METEOR MK. 8 WF. 716
(SERMENT 8)

RADIO ACCEPTANCE TRIALS

A. & A.E.E. Ref:- A.A.E.E./411/27/Radio
M. O. S. Ref:- 44th Joint Radio Meeting, A. & A.E.E.- M.O.S.
Period of Trials:- 2nd January, 1953 to 14th May, 1953.

FIG. 1.

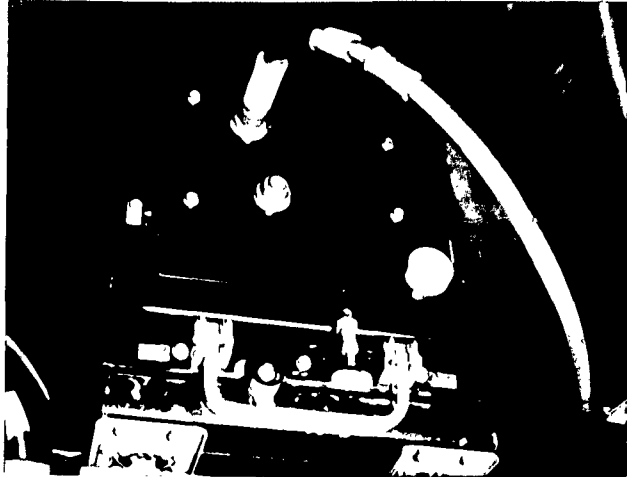
3.1.2 The transmitter aerial co-axial feeder was considered too long, and liable to be damaged by personnel working in the radio bay. (Fig. 1) The use of a 90° entry plug fitted to the feeder, would enable the cable to be laid over the top of the transmitter unit, thus reducing the feeder length.

4.1 The transmitter co-axial feeder should be re-routed over the top of the transmitter receiver, thus reducing the length of co-axial feeder, and a 90° entry plug substituted for the straight entry plug fitted.

FIG. 3.

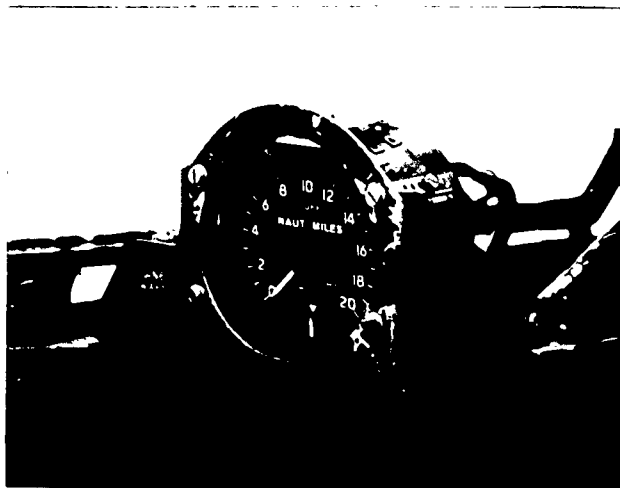
3.1.7 The Range and Heading Indicator was mounted on a resilient mounting on the port side of the cockpit, angled towards the pilot. (Fig. 3.) This position was satisfactory for observation, but greater ease of observation would be achieved if the indicator was moved back as far as possible in its present attitude. The use of the 90° entry socket on the connector from the Junction Box to the indicator would facilitate this alteration of indicator position, and would also be better for servicing.

3.4.3 During night flying the Range and Heading Indicator was difficult to read, as it was out of the area of instrument lighting.

4.2 The straight entry plug on the junction box-indicator connector should be replaced by a 90° plug. This would facilitate servicing, and enable the indicator to be set closer to the instrument panel.
